AS CONSTRUCTED SEPTEMBER

NOT FOR CONSTRUCTION

CITY OF SANDY
WASTE WATER TREATMENT FACILITY
IMPROVEMENTS
SECONDARY CLARIFIER
MECHANICAL PIPING PLAN

1 SECONDARY CLARIFIER PIPING PLAN
M10 SCALE: 1/8" = 1'

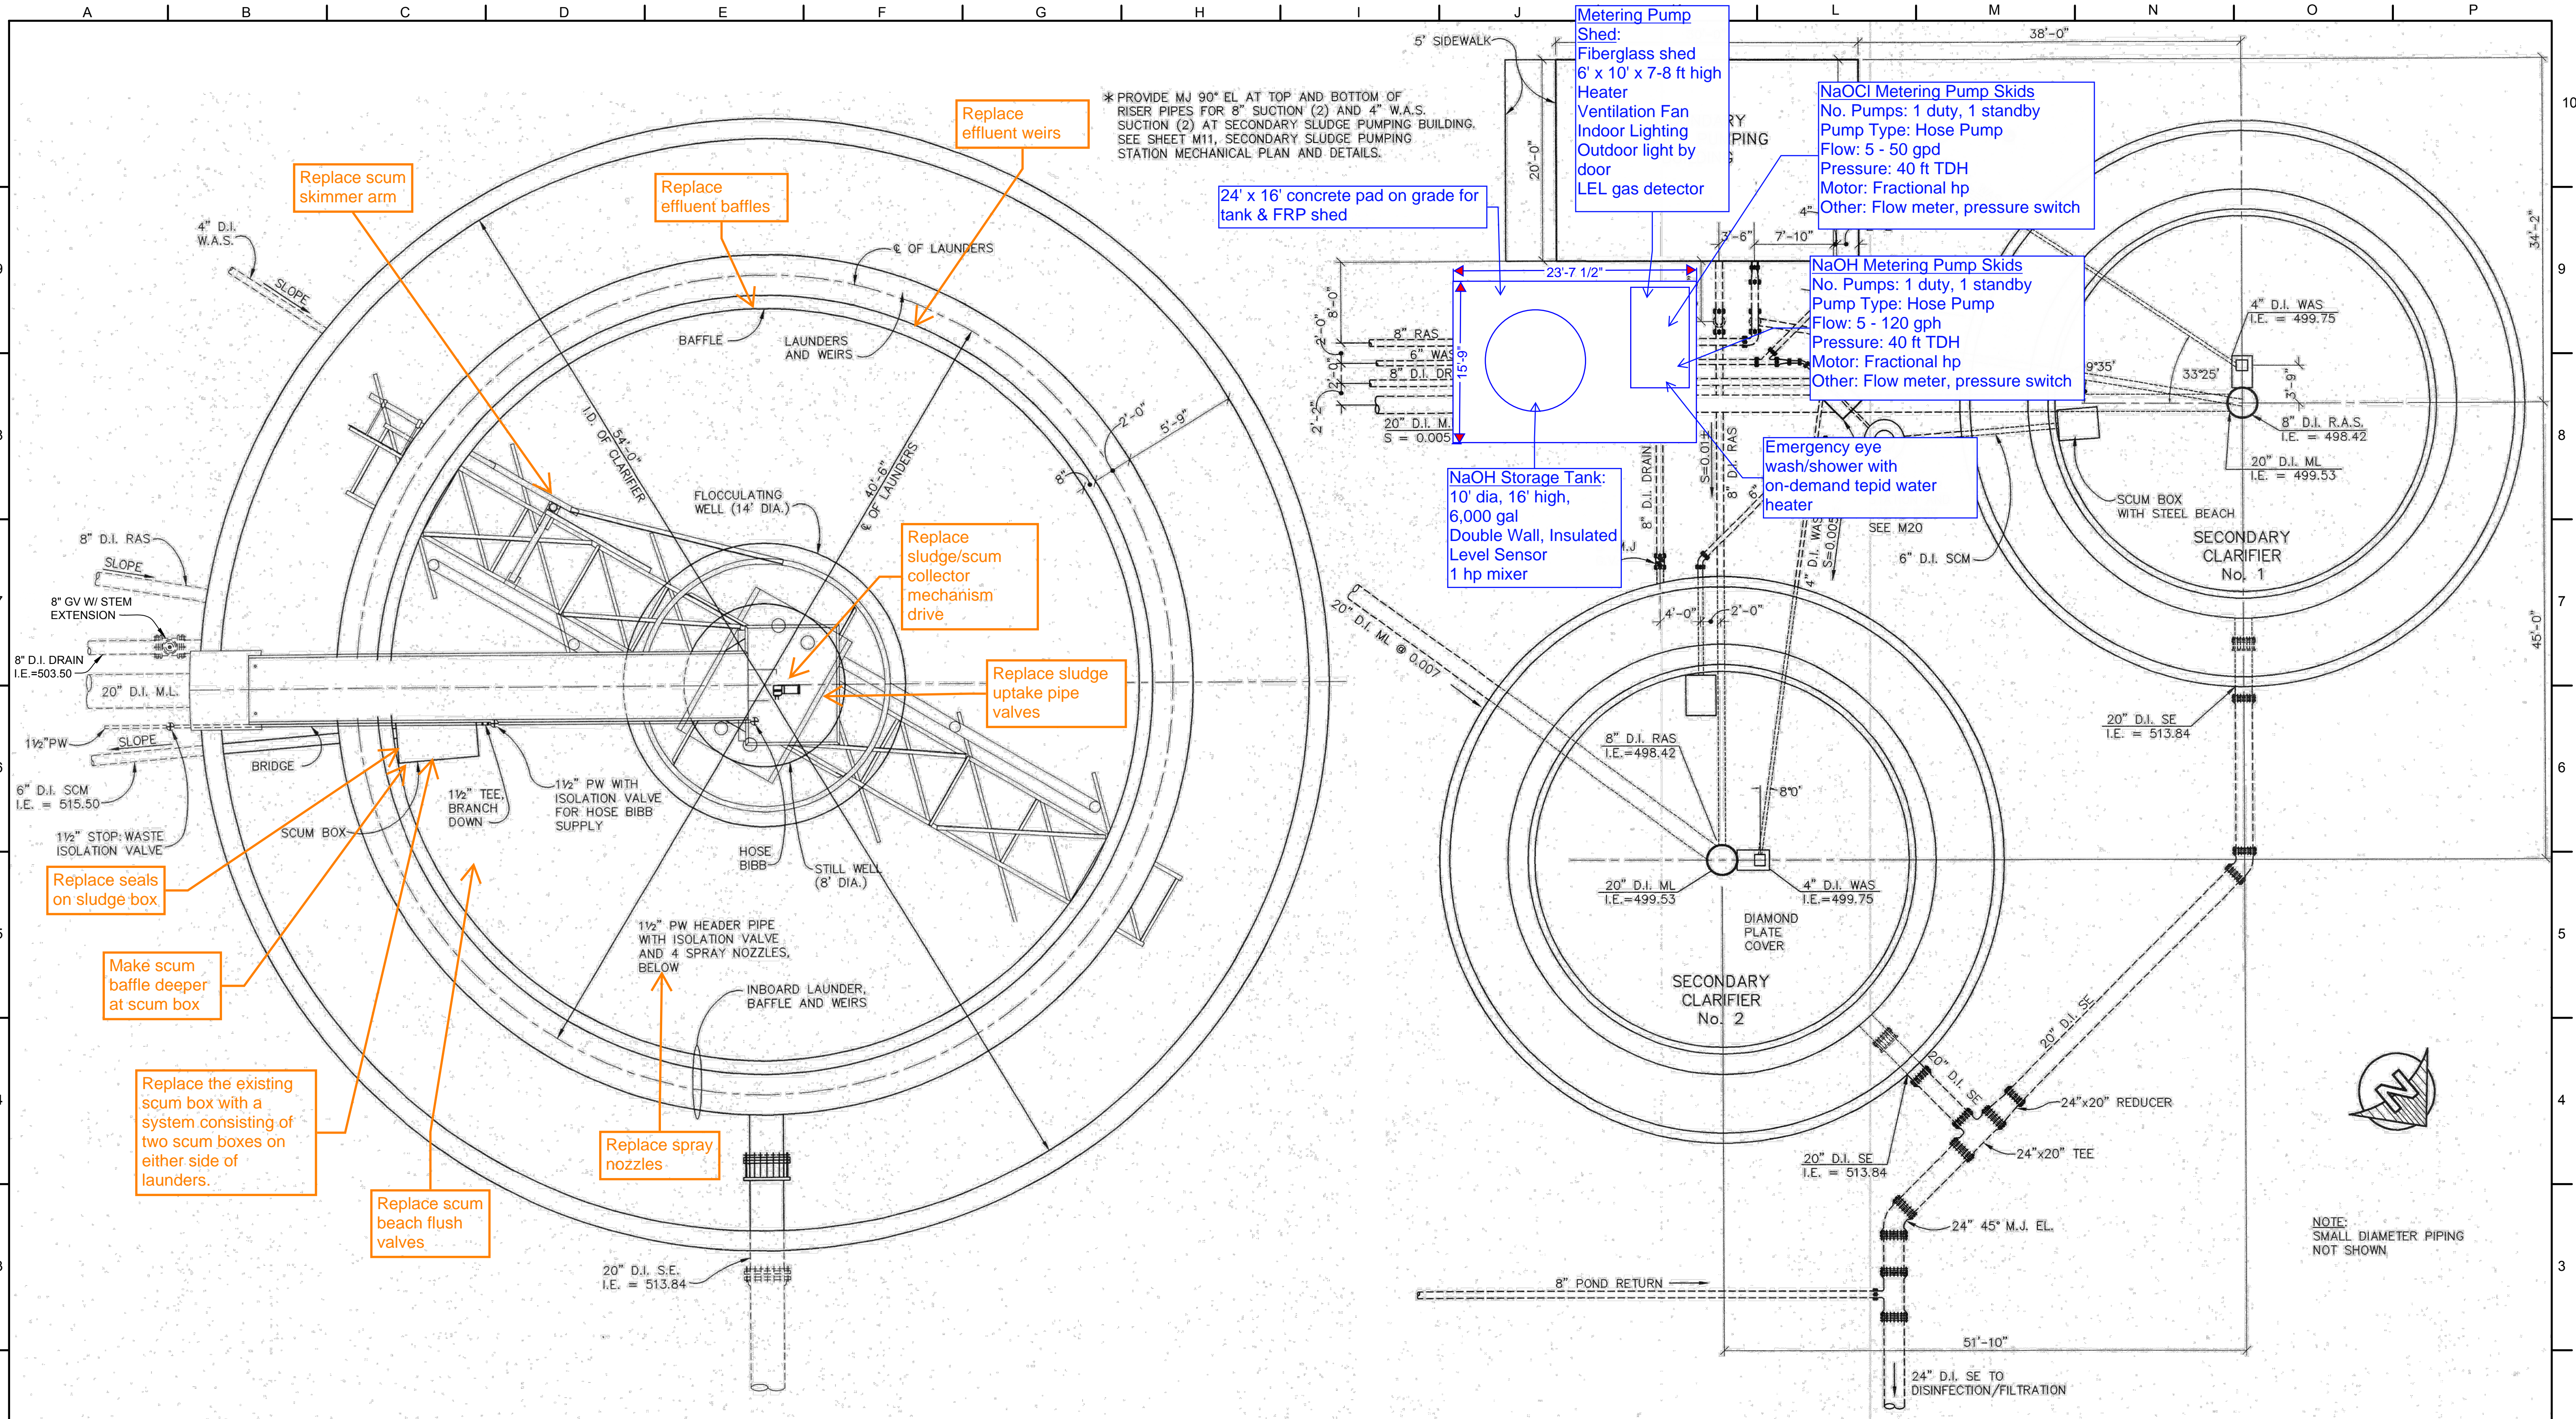
Replace scum skimmer arm

Replace effluent baffles

Replace effluent weirs

Replace sludge/scum collector mechanism drive

Replace sludge uptake pipe valves

Replace seals on sludge box

Make scum baffle deeper at scum box

Replace the existing scum box with a system consisting of two scum boxes on either side of launders.

Replace scum beach flush valves

Replace spray nozzles

1 BLOWER BUILDING MECHANICAL & PLUMBING PLAN
 M16 SCALE: 1" = 1'-0"

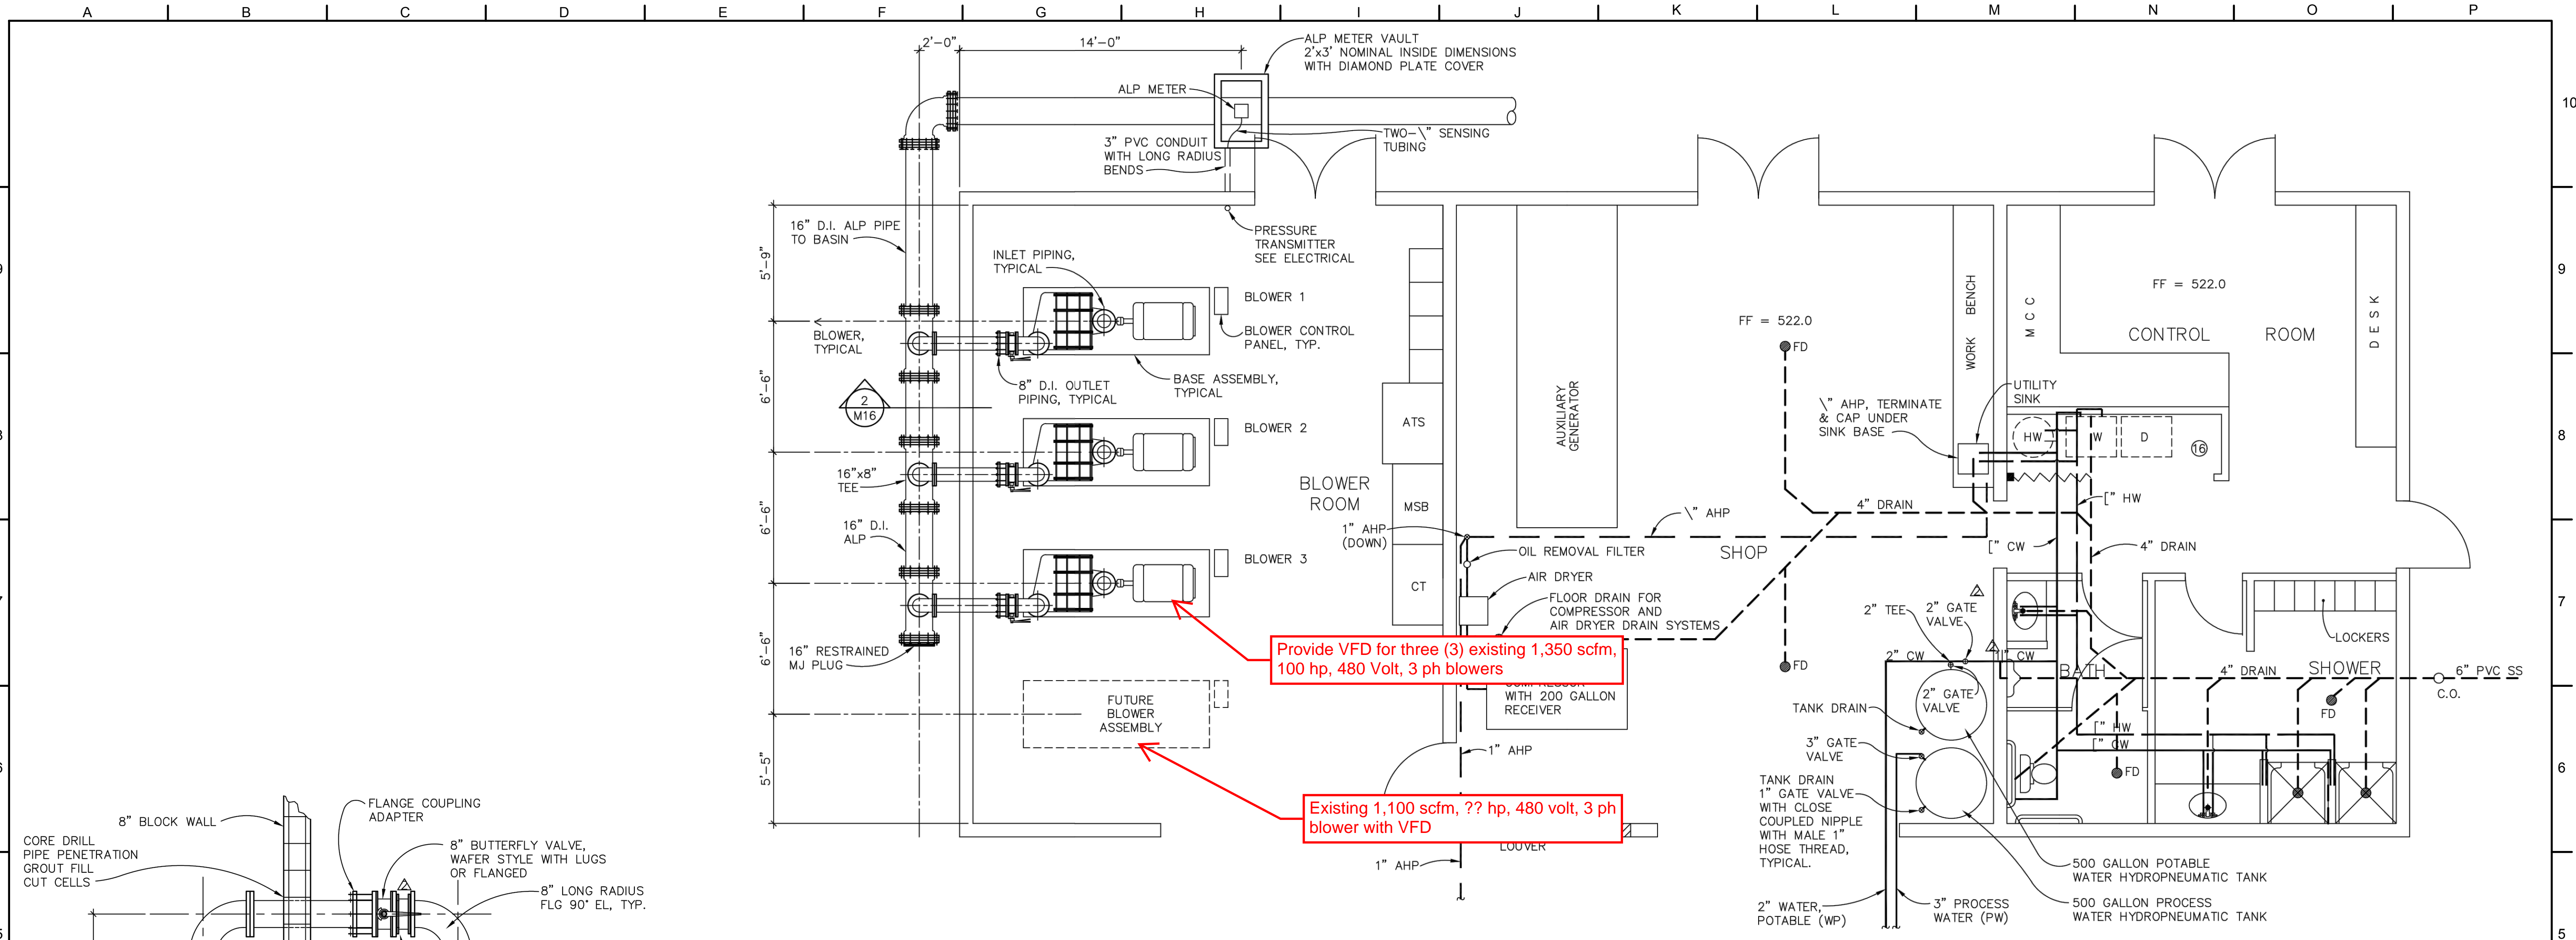
Provide VFD for three (3) existing 1,350 scfm, 100 hp, 480 Volt, 3 ph blowers

Existing 1,100 scfm, ?? hp, 480 volt, 3 ph blower with VFD

1 SLUDGE STORAGE TANK MECHANICAL PLAN
M17

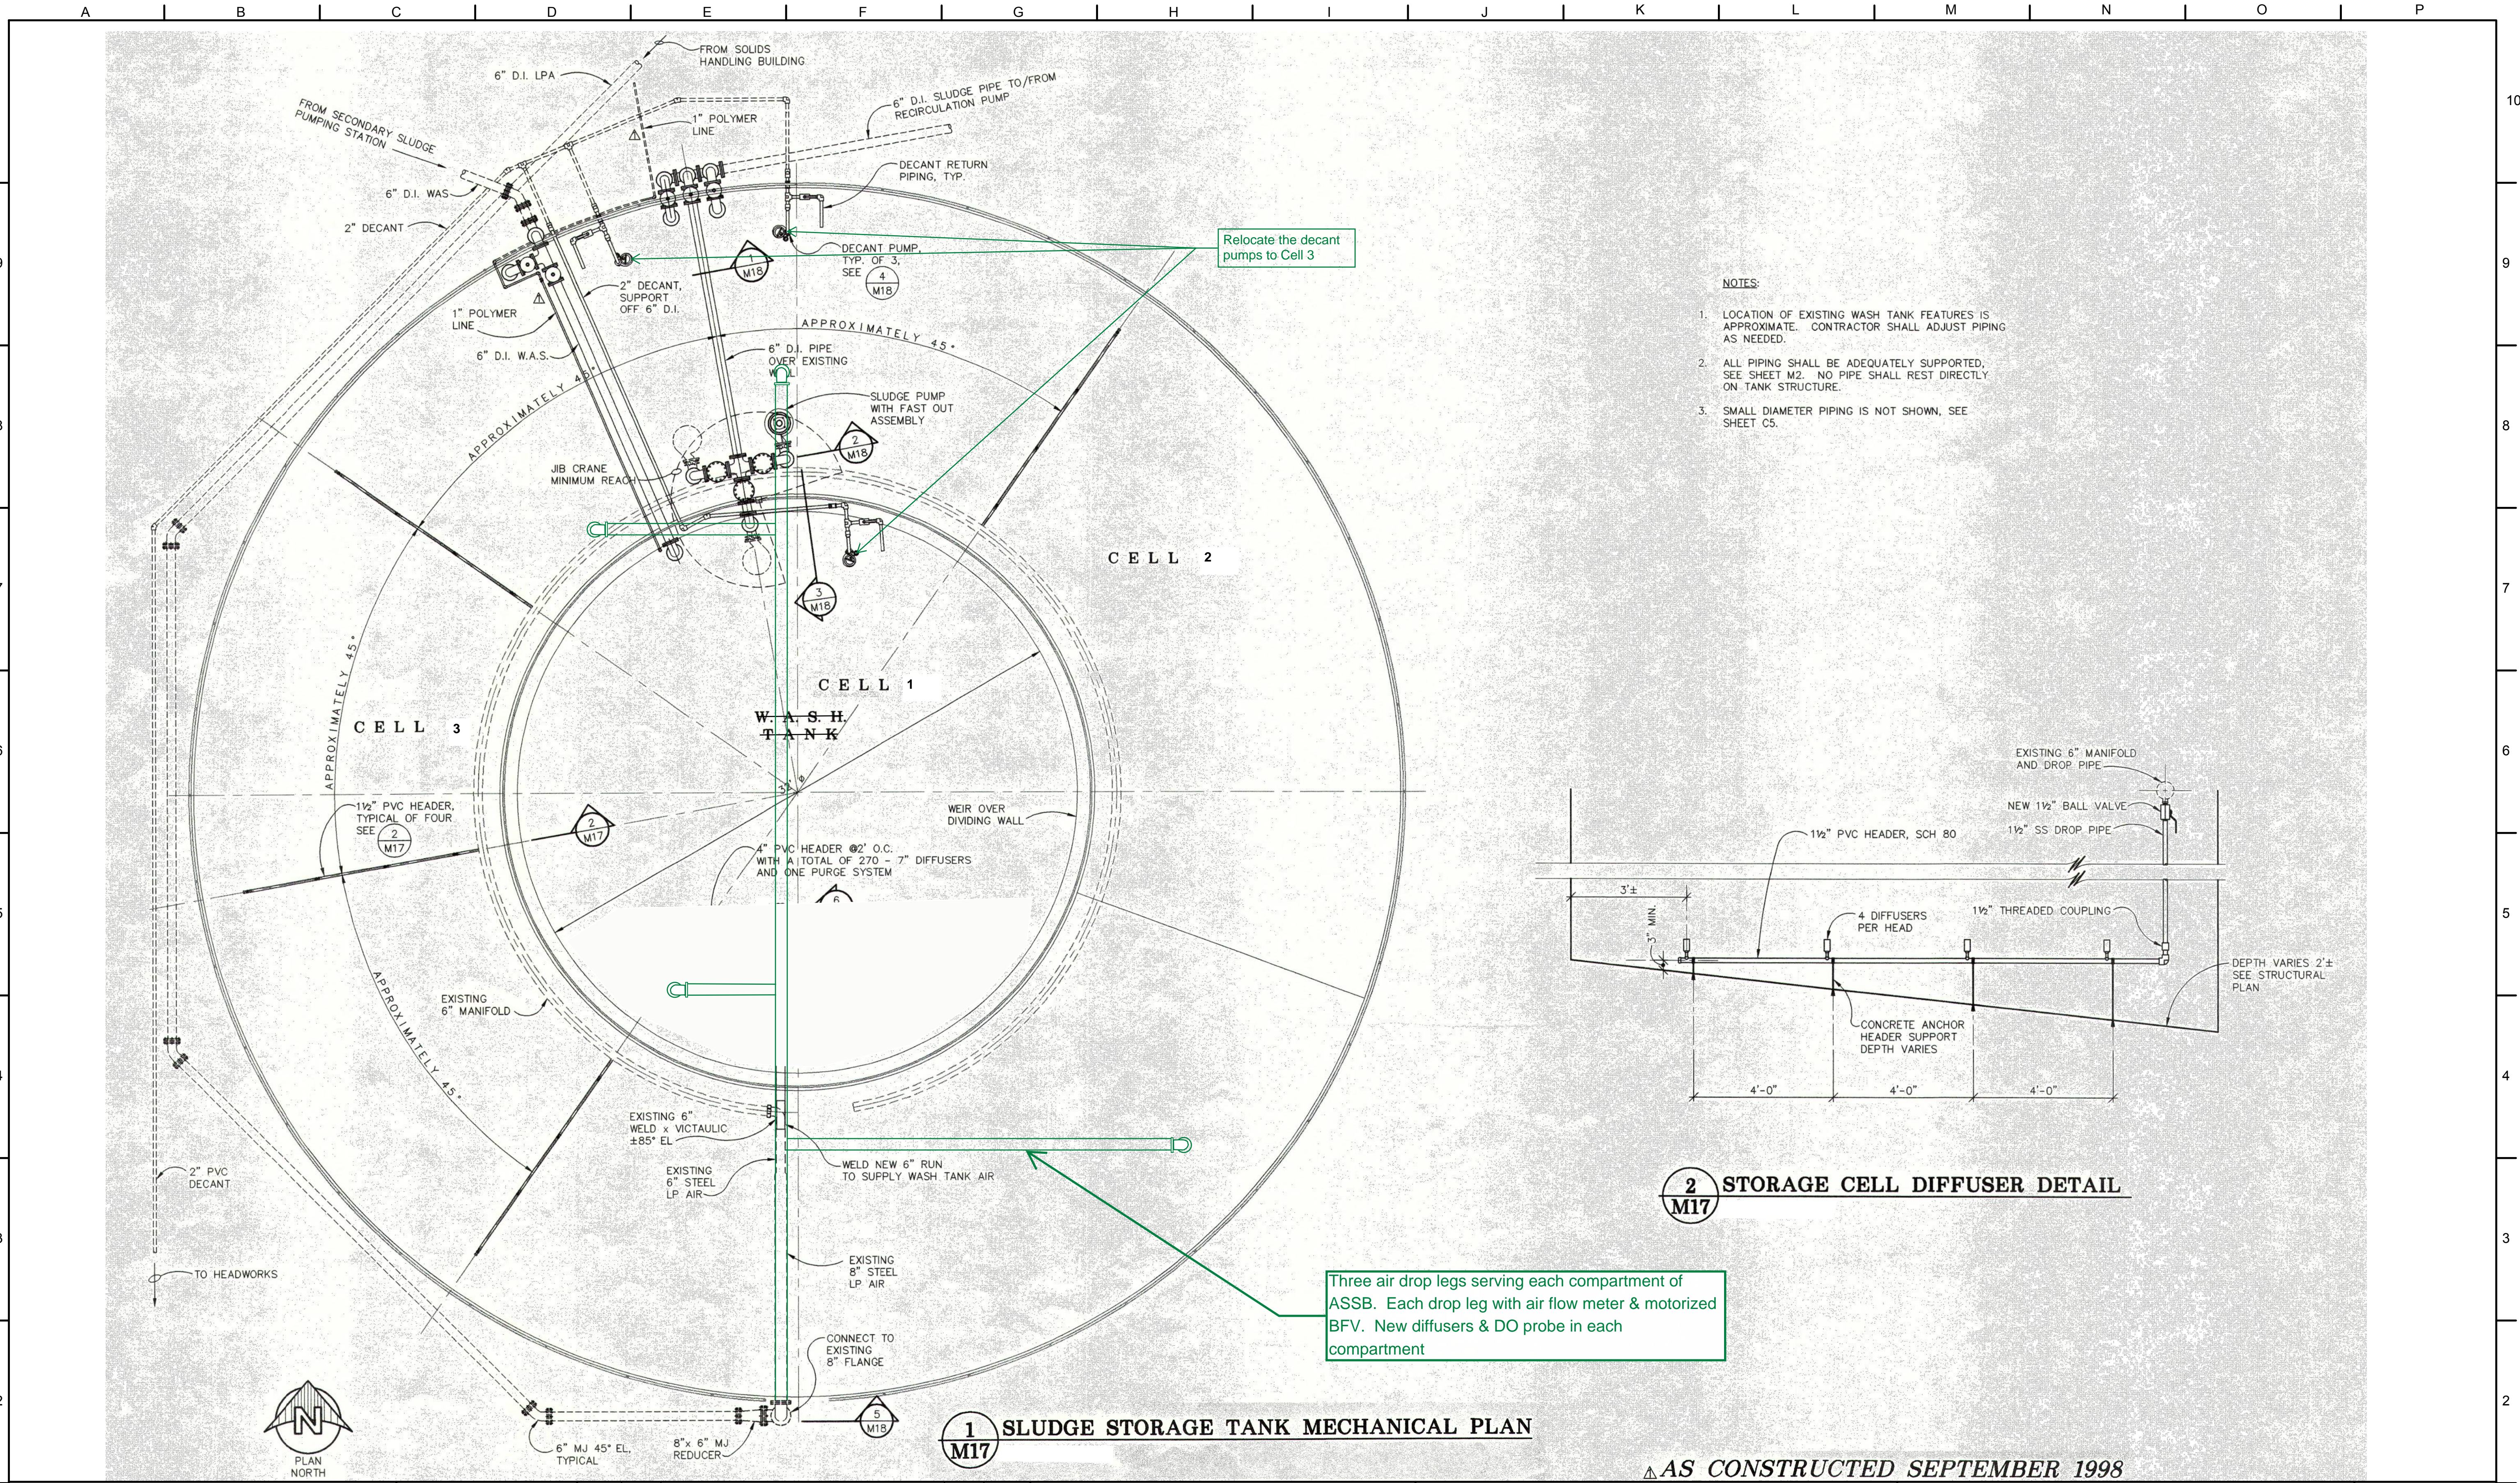
Three air drop legs serving each compartment of ASSB. Each drop leg with air flow meter & motorized BFV. New diffusers & DO probe in each compartment
